## FIELD OBSERVATION REPORT

Central Hardin High School, Cecilia, KY

2019111 -CA8

Report No: 12

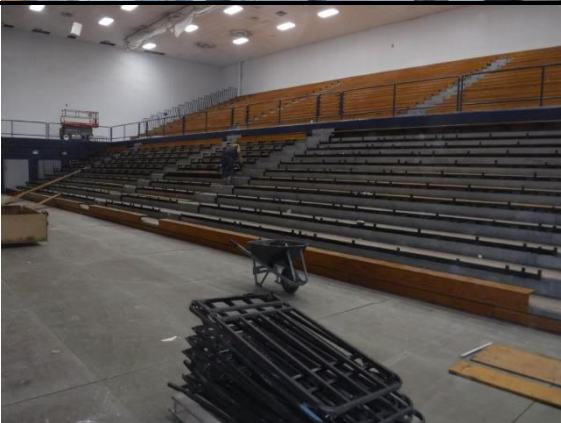
Item No.	Location	Description/Correction	Image	Action
7	Area A	Most of the hollow metal door frames have mortar setting on top the frame.		Remove mortar without damaging the frames.
8	Area A	The ground faced block had been covered when the regular block was laid above it. As a result, the ground faced block is clean.		Continue to protect block so it stays clean and not damaged.
9	Area A	In general, blockwork is being laid in plane and with uniform joints. Chipping is at a minimum. The block is clean.		None

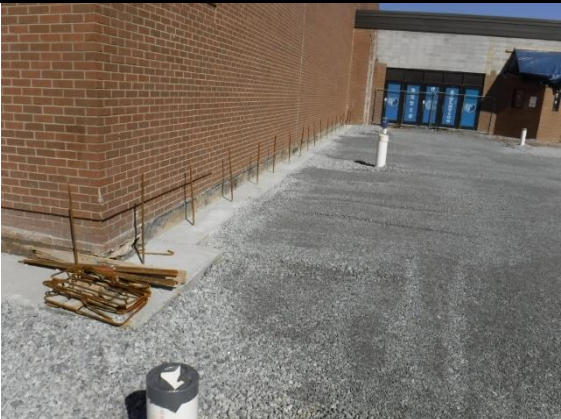
Item No.	Location	Description/Correction	Image	Action
19	Area C Gym	It has been discovered that some of the electrical panels in Area C serve areas outside of the renovation. STW is working with AES to resolve these issues.	 A photograph showing two open electrical panels mounted on a wall. The wall is white with a blue baseboard. A yellow cable is visible on the left panel. The right panel shows internal wiring and components.	Respond to the RFI.
20	Area B	Masons were laying block in the ROTC area on the gym level.	 A photograph showing a construction site with scaffolding. A worker in a blue hard hat and safety vest is standing on the scaffolding, working on a wall. A concrete mixer truck is visible in the background.	None
21	Area B	Alliance was placing steel reinforcement over helical piles for the footings for the foundation walls to the south of the existing building.	 A photograph showing a construction site with a large area of steel reinforcement being laid out. A worker in a yellow safety vest is visible. A generator is in the foreground, and a large black tarp is in the background.	None
